CAPE COD COMMISSION

PROJECT: Christy's of Cape Cod – Phase 1, CanalSide Commons
Route 28 at the Bourne Rotary
Bourne, MA

RE: Development of Regional Impact
Cape Cod Commission Act, Sections 12 & 13

DECISION OF THE CAPE COD COMMISSION

99-093
SHEET 1 OF 1
PROPOSED CHRISTY'S MARKET
5 MACARTHUR BOULEVARD
BOURNE, MASSACHUSETTS
FOR CHRISTY'S OF CAPE COD
105 PLEASANT STREET, HAMMAM, MA 02601

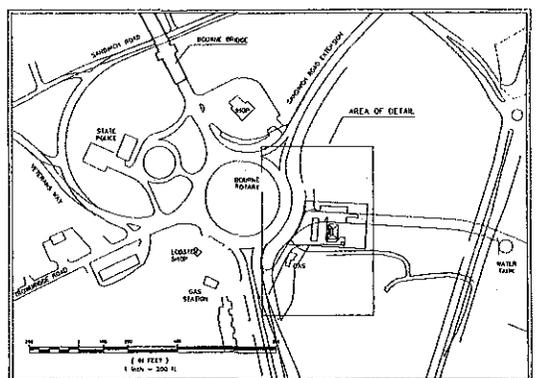
TR3. Christy's of Cape Cod has proposed to provide right-in, right-out access to/from the Route 28 northbound lanes, as shown in the site plan #99-093 dated April 17, 2000, latest revision dated 11/2/01 (sic) (misdated, actually received 1/2/01). This plan creates more separation between the Bourne Rotary and the site drive, compared to the previous Texaco Station access. The distance from the center of the Bourne Rotary travel lanes to the center of the site drive will measure a minimum of 275 feet, to meet the Town of Bourne's driveway spacing requirements. Christy's might have access/egress onto Sandwich road as part of subsequent development phases. Such access/egress is not proposed as part of this phase of development.

TR1. Prior to issuance of a Final Certificate of Compliance, Christy's shall locate their site drive in accordance with the site plan #99-093 dated April 17, 2000, latest revision dated 11/2/01 (sic) (misdated, actually received 1/2/01). The site drive on the Route 28 (MacArthur Boulevard) northbound lanes shall be right-in and right-out only.
